CONSTRUCTION OF NEW MUNICIPAL SOFTBALL PARK REBID

PROJECT NO.: 08-18-C28-608

A D D E N D U M NO. 1

ADDENDUM No 1
SOFTBALL FIELD FACILITIES
MUNICIPAL PARK
McALLEN, TEXAS

C3.02

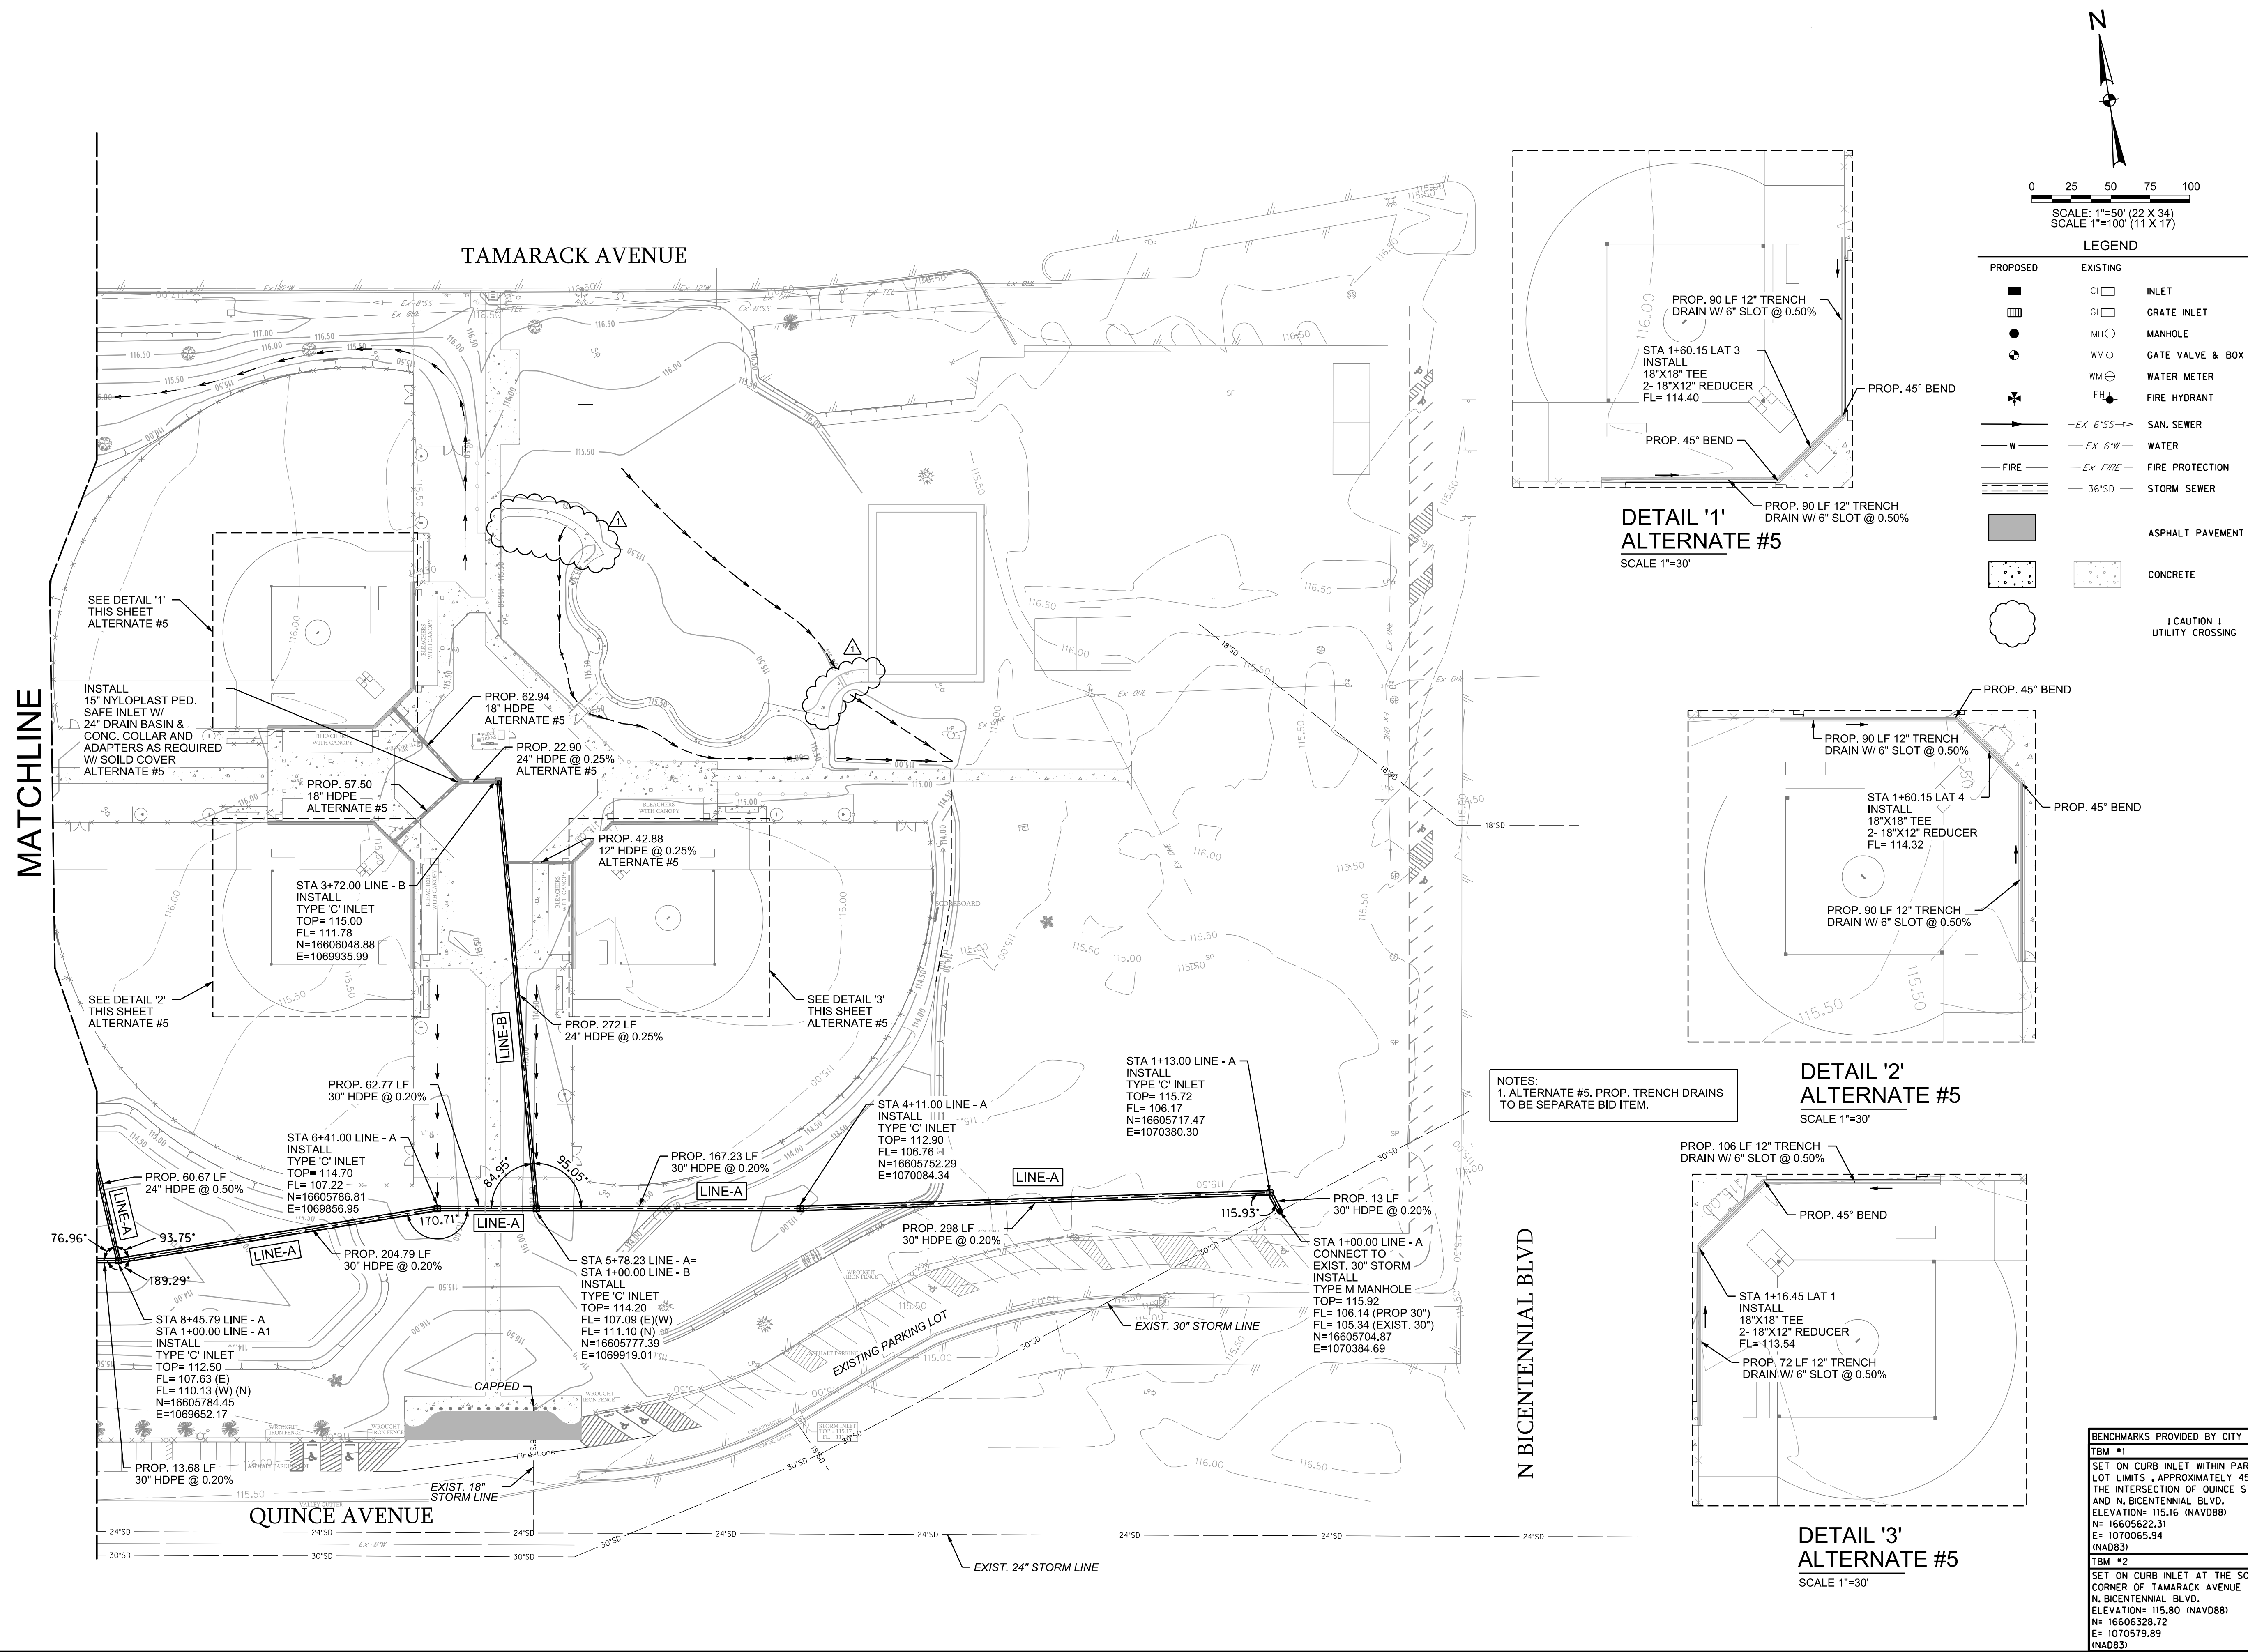
- C2.02 Modified elevation for the playground and basketball court flatwork (Alternate) to reflect site plan changes.
- C3.02 Modified references files to reflect site plan flatwork changes.
Added Alternate 5 – Backstops Trench drains and underground system.

Project No.:	33348.001
Issued:	07/11/2018
Drawn By:	G.Q.
Checked By:	B.S.
Scale:	AS SHOWN
Sheet Title	FLOOR PLAN & REFLECTED CLG. PLAN
Sheet Number	A2.1

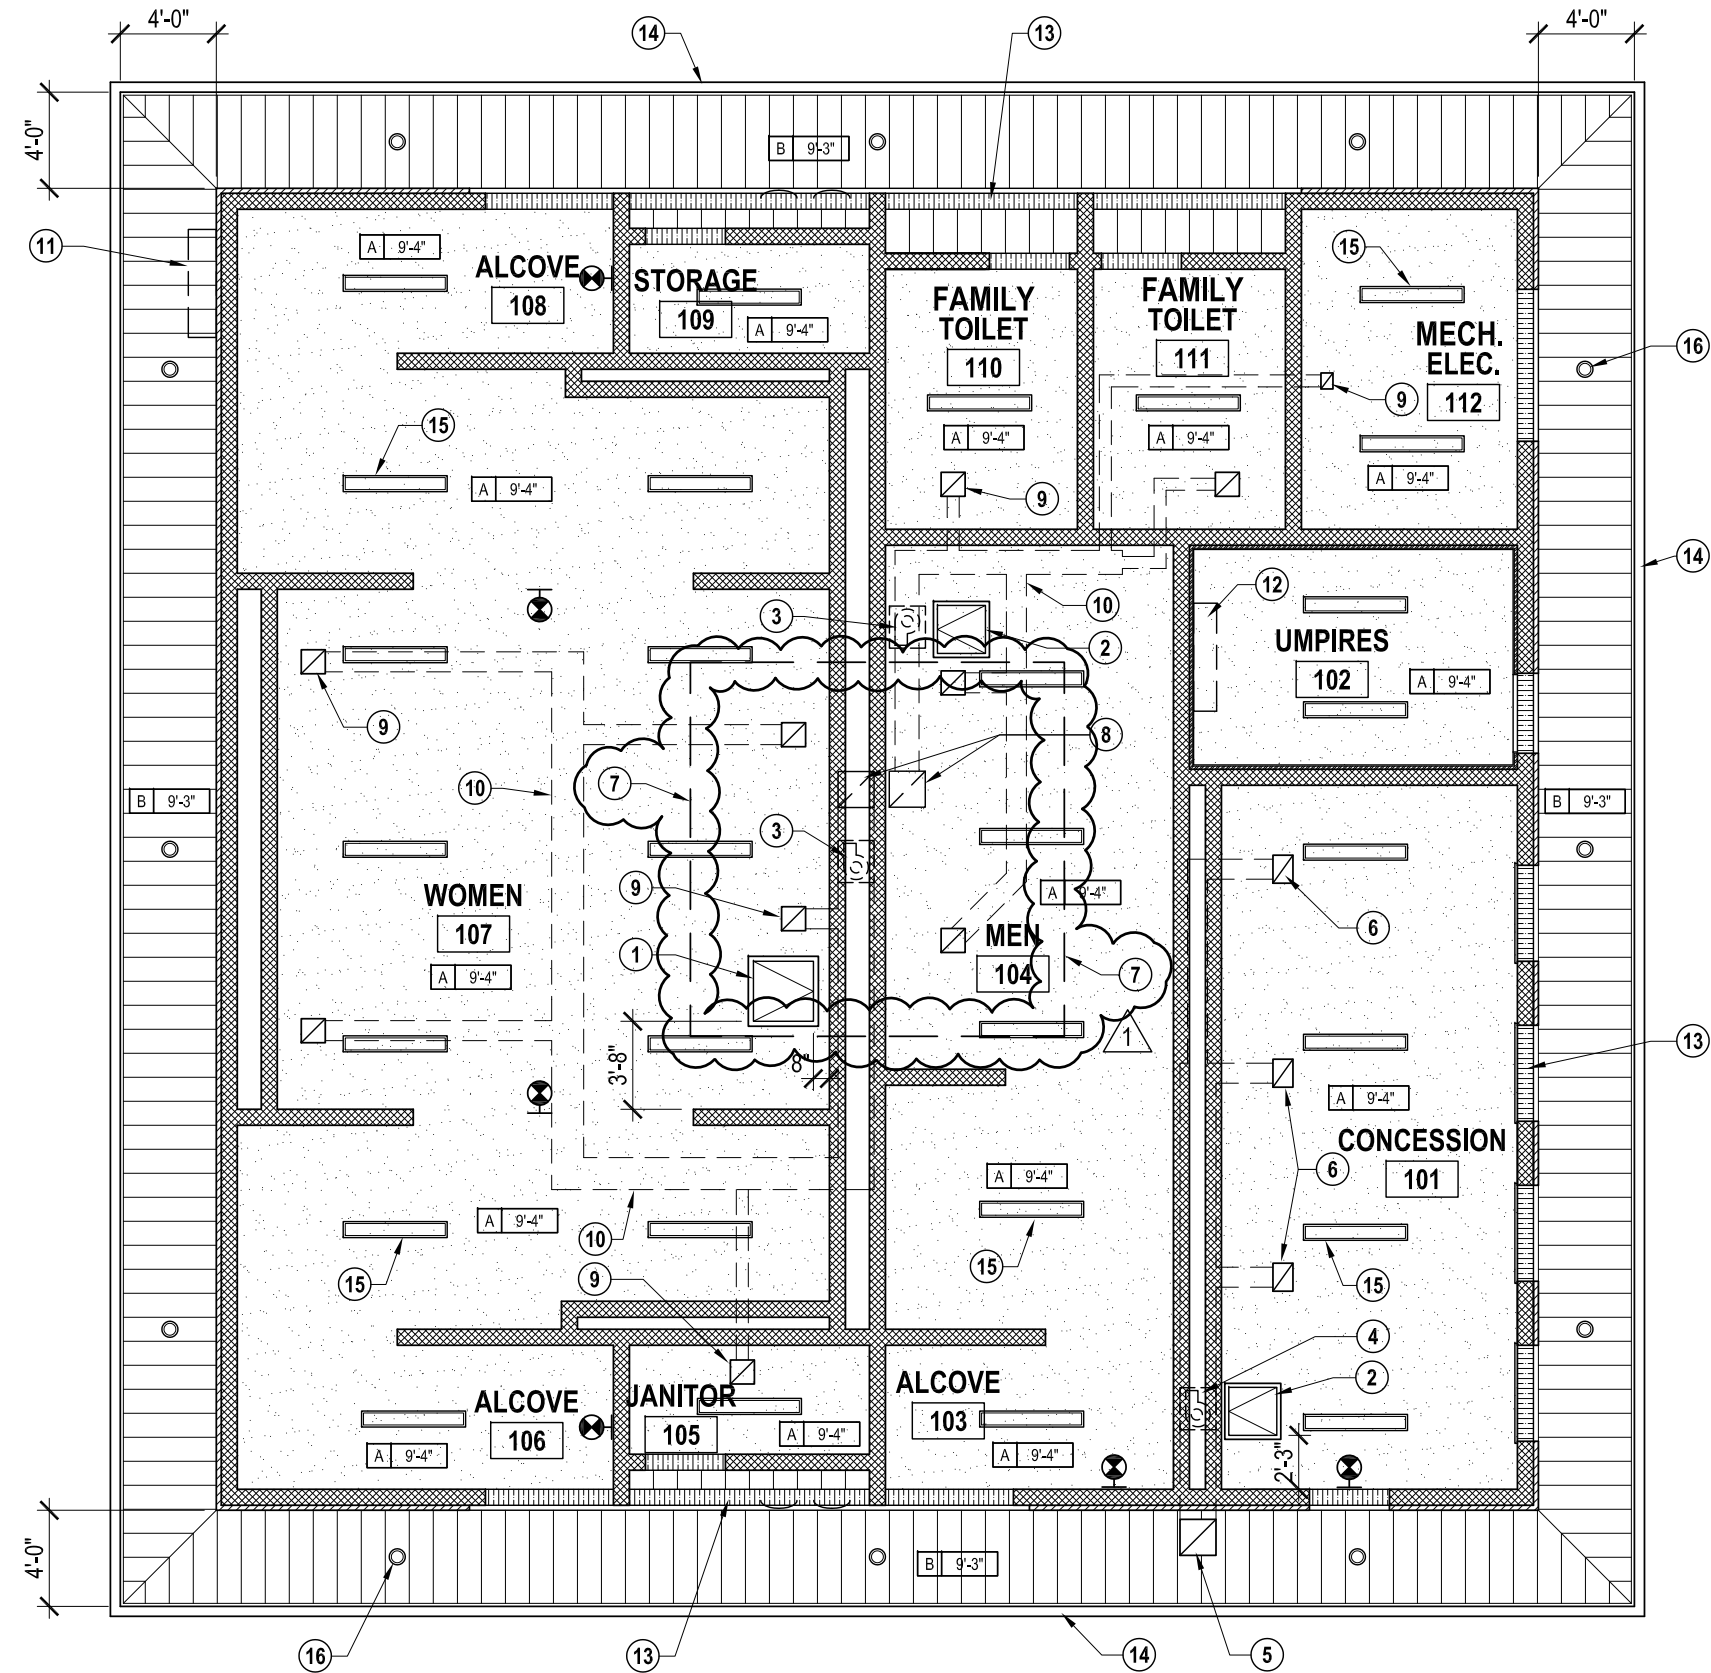
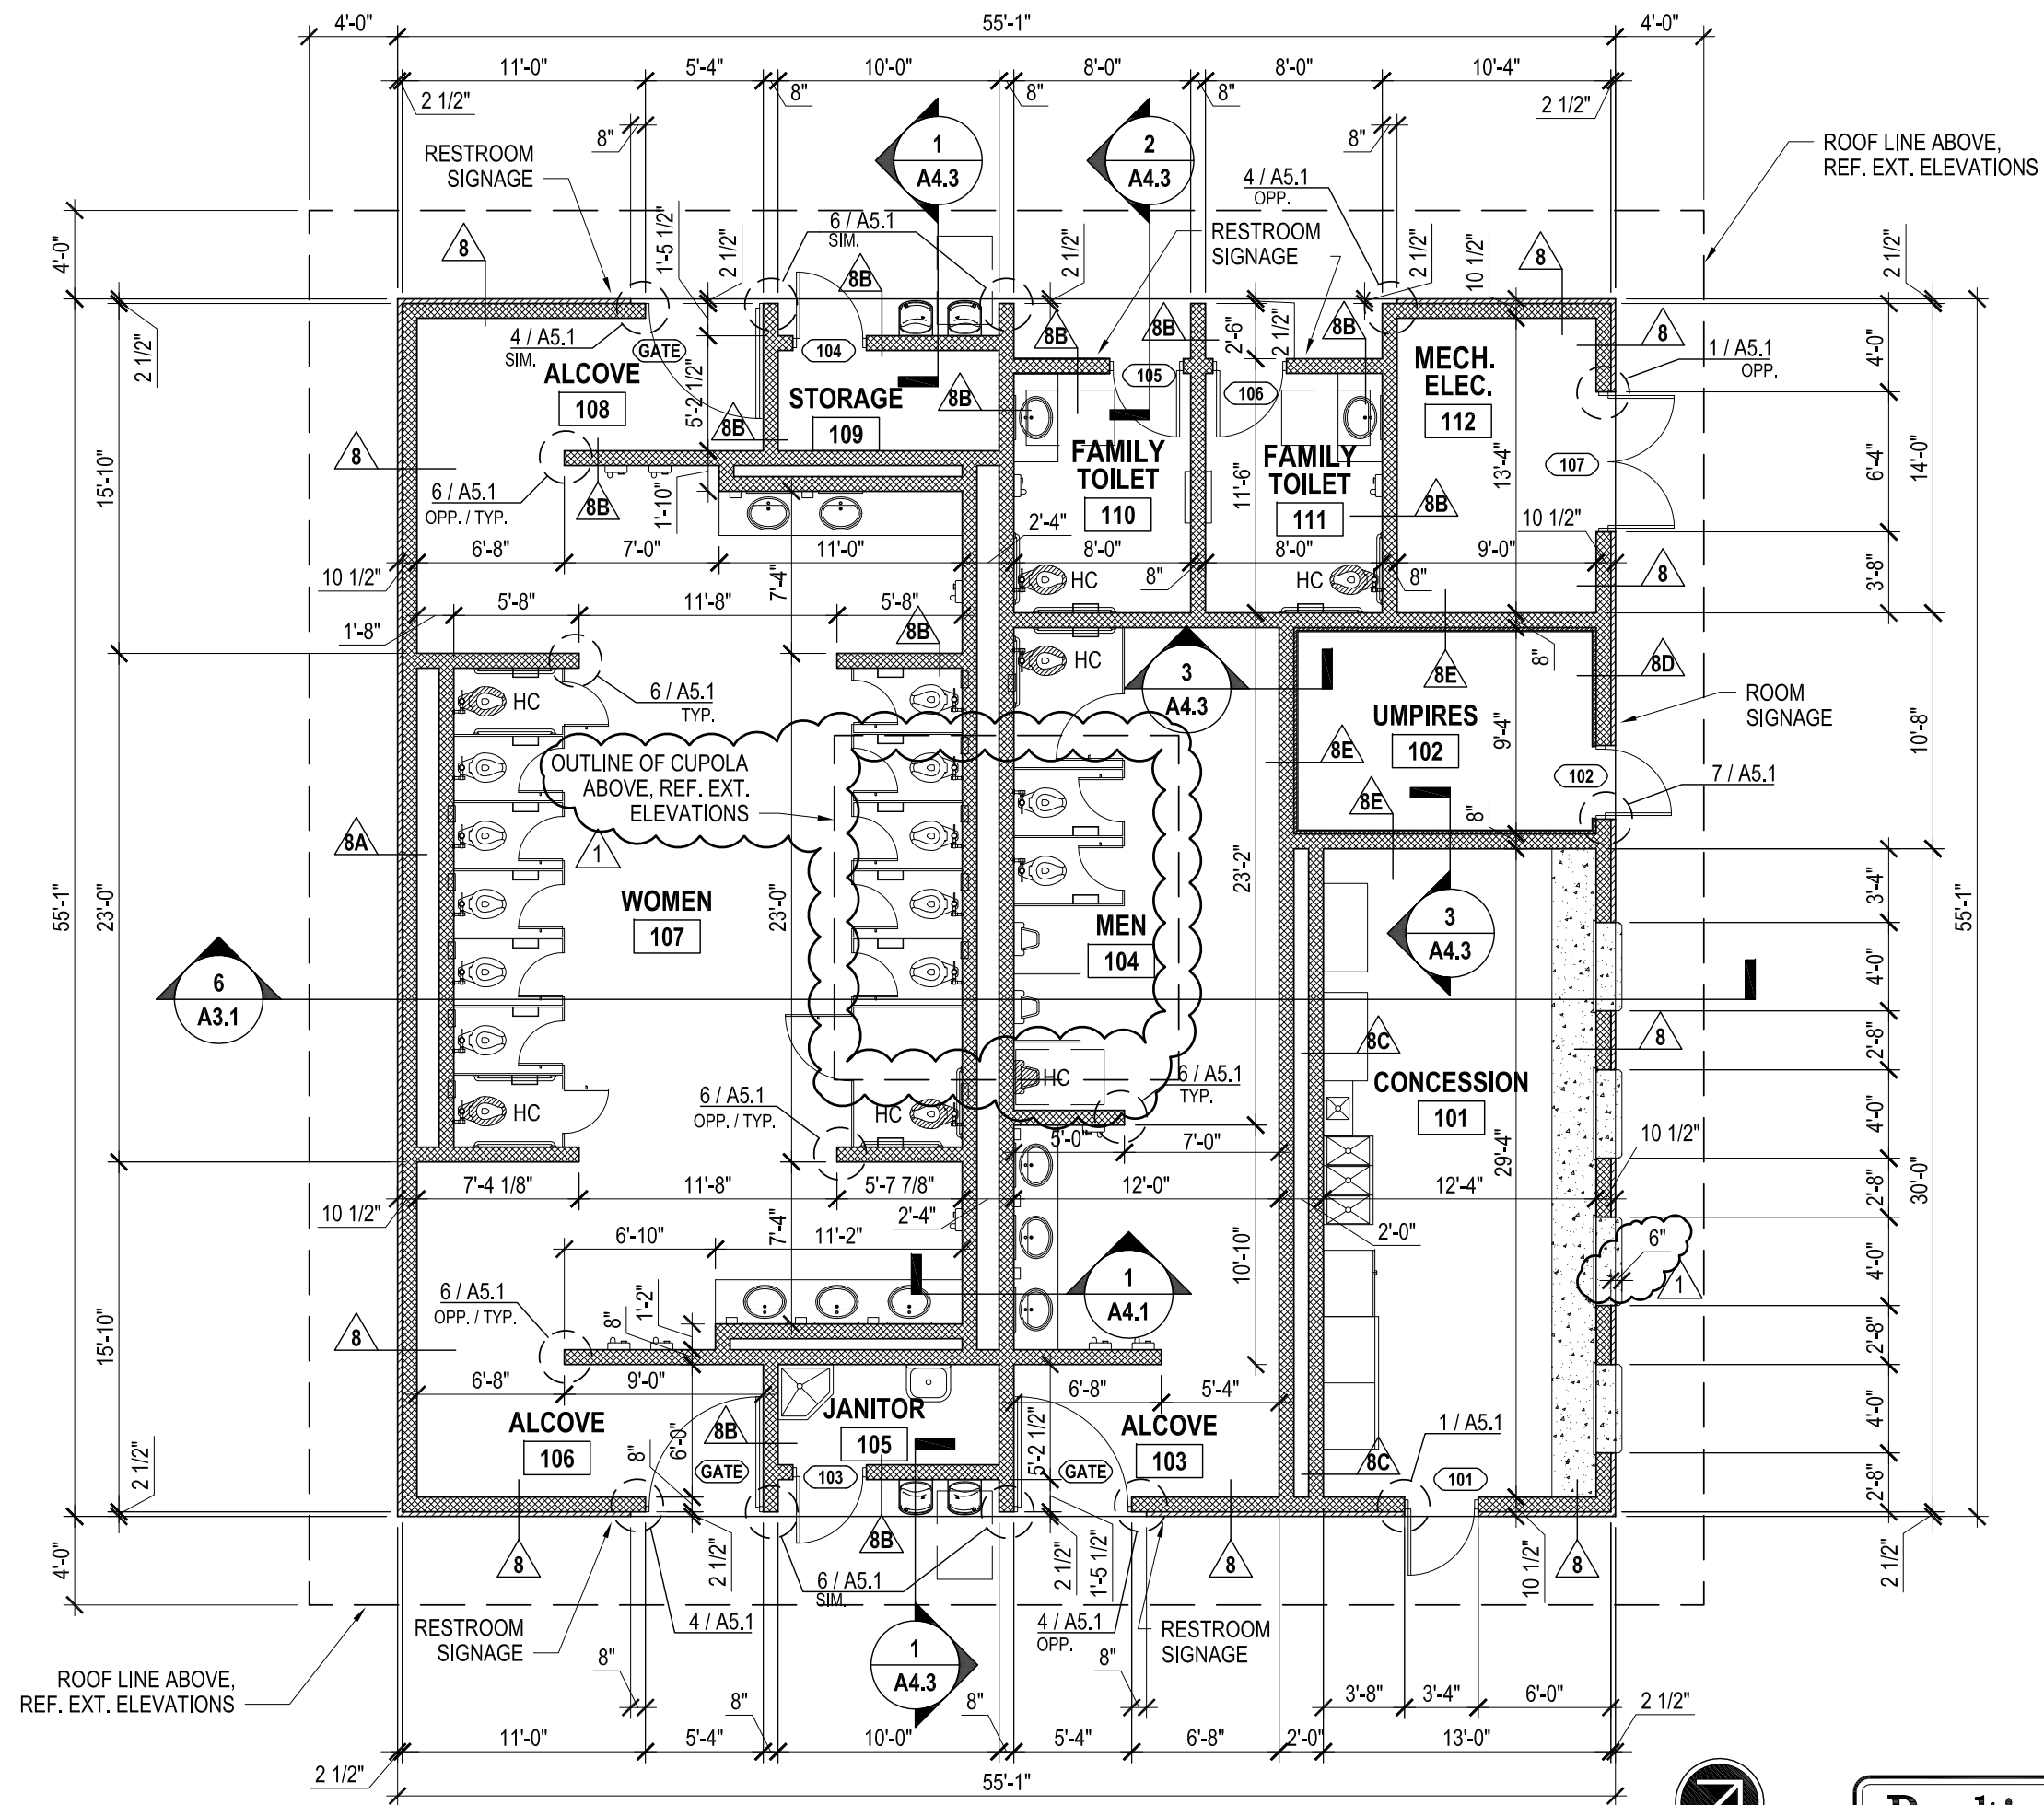
- A2.1 Added outline of Cupola wall above. Added RCP key note #7 & revised key note #8.
- A2.2 Relocated ADA urinal, added ADA notes & dimensions.
- A2.3 Relocated ADA urinal, added ADA notes & dimensions.
- A3.1 Added Cupola & material call outs.
- A4.1 Added wall section at Cupola. Added ADA notes & dimensions.
- A4.2 Added wall detail at Cupola.
